**Special Use Permit Application SUP-21-02  
Henderson County Zoning Board of Adjustment**

**July 28, 2021**

**Proposed Crab Creek Mini Storage Facility  
547 Crab Creek Road, Hendersonville, NC**

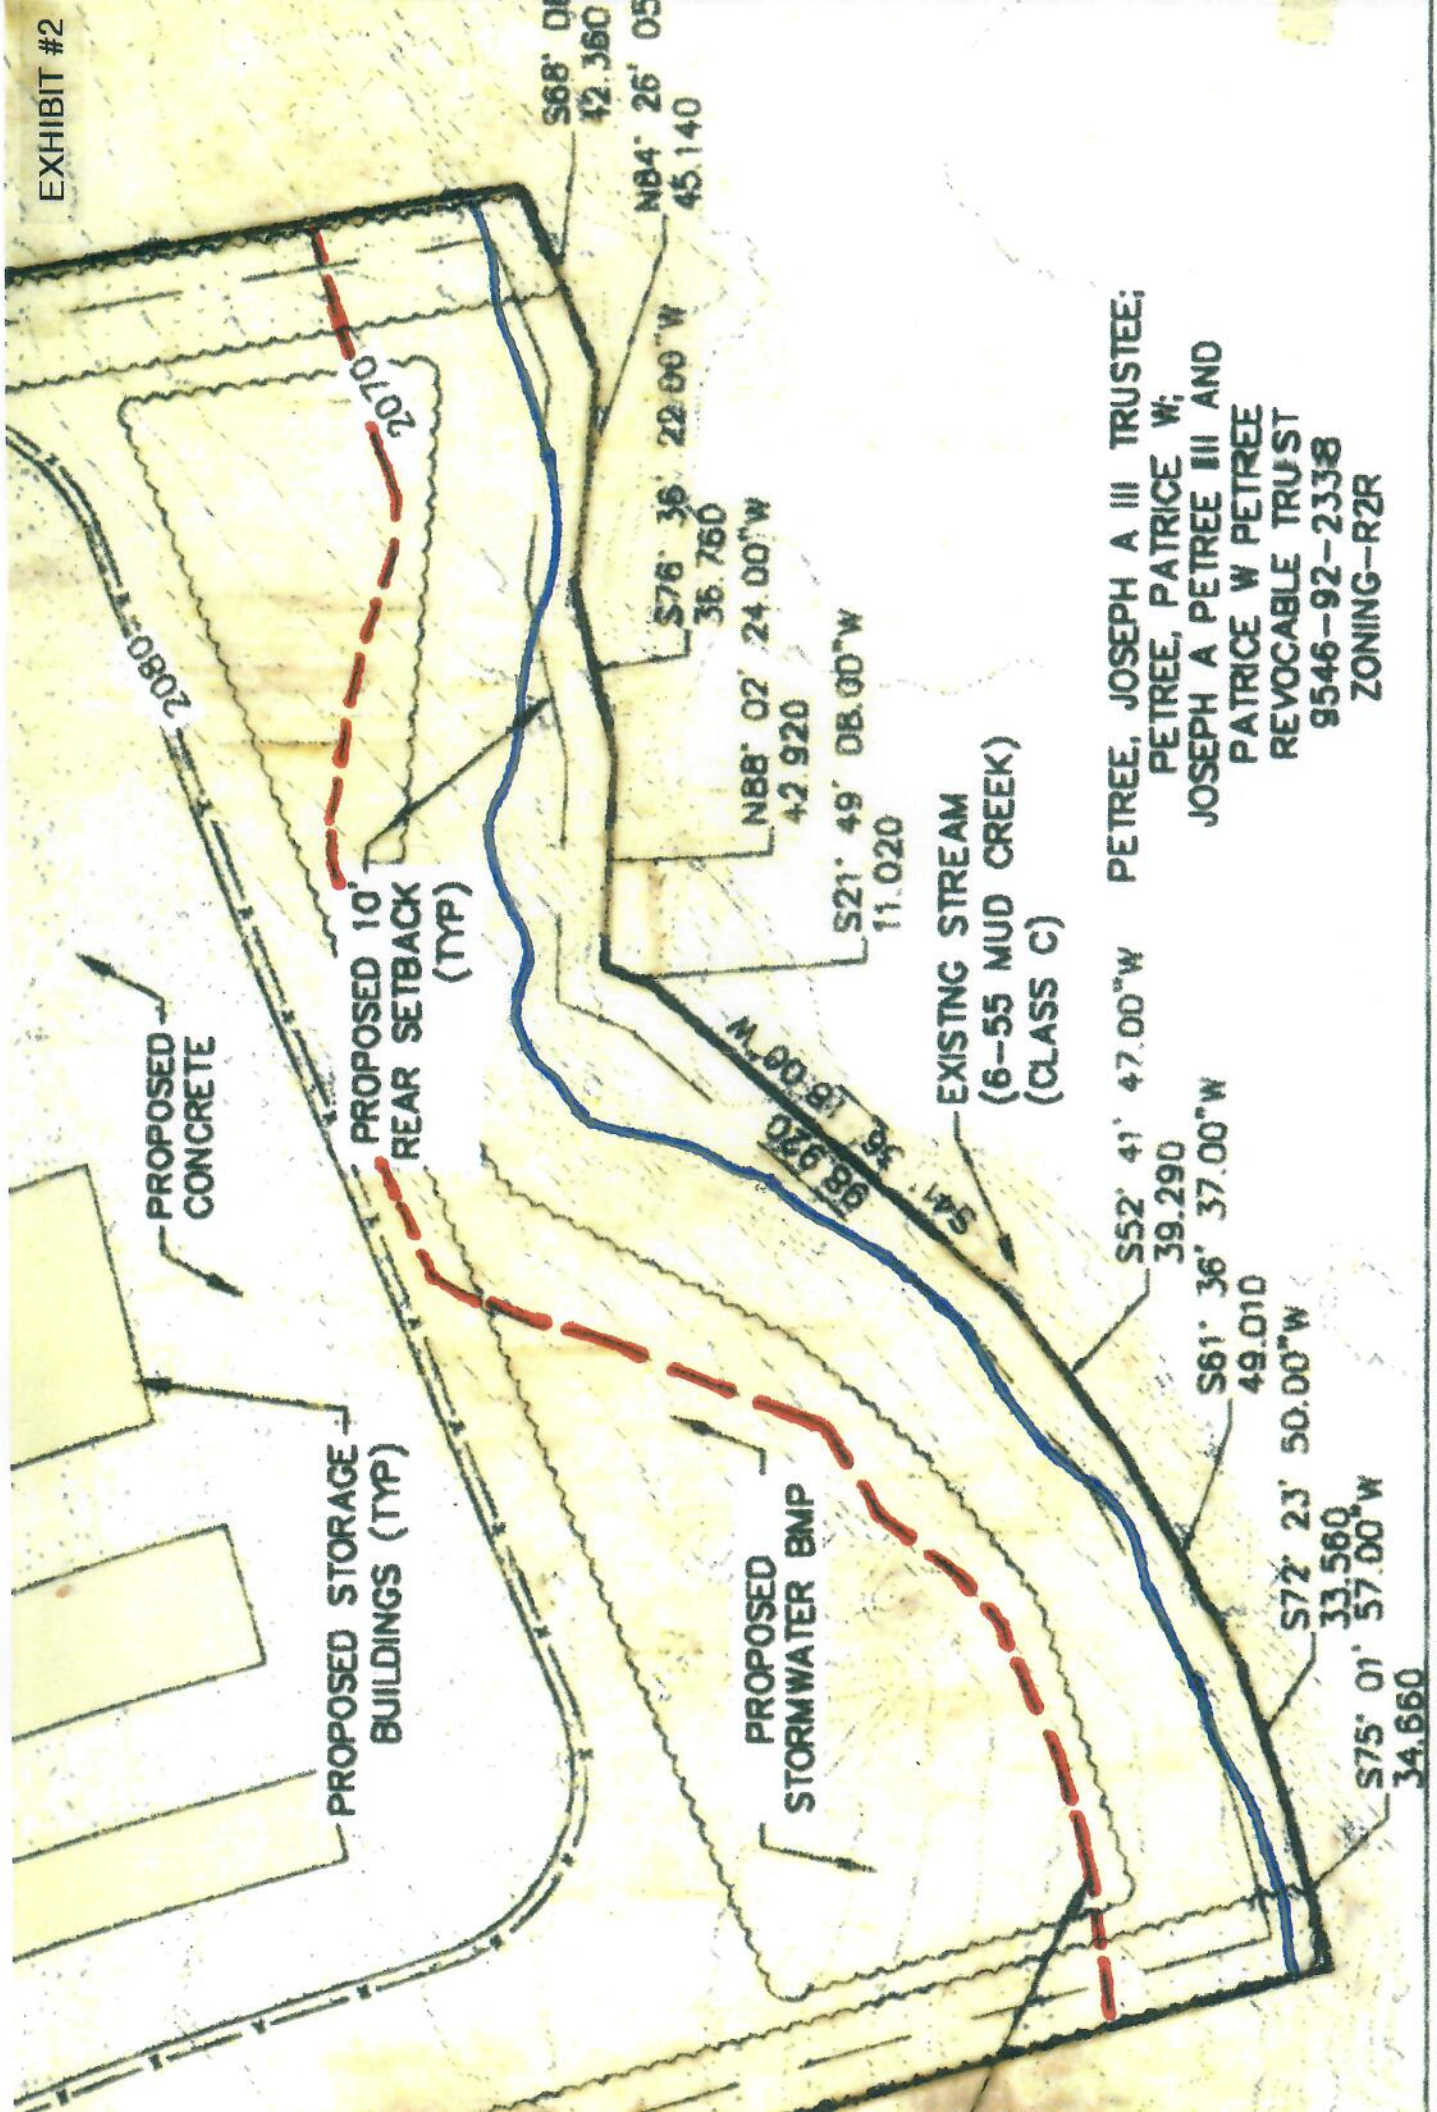
- a. The proposed wastewater site is in the northwest corner of **Exhibit #4** and as shown in the **SUP-21-02**.
- b. Caroline J. Edwards conducted soil investigations on the adjacent property, so as not to trespass onto the subject property. Caroline Edwards' soil profile description is at **Exhibit #5**. The soils adjacent to Crab Creek Road have a seasonally high water table at 18-inches below the ground surface. This area consists of an upper river terrace and is present on the subject property where the soil is "naturally occurring". The seasonally high water table makes the site unsuitable for septic systems.
- c. Caroline J. Edwards also described that some of the subject property has been highly disturbed as noted at **Exhibit #5**. Where the soils are not "naturally occurring" no on-site wastewater system can be allowed.

**Opinion #4** – Construction as proposed by the applicant will violate the State On-Site Wastewater Treatment regulations and will endanger the public health, safety and welfare.
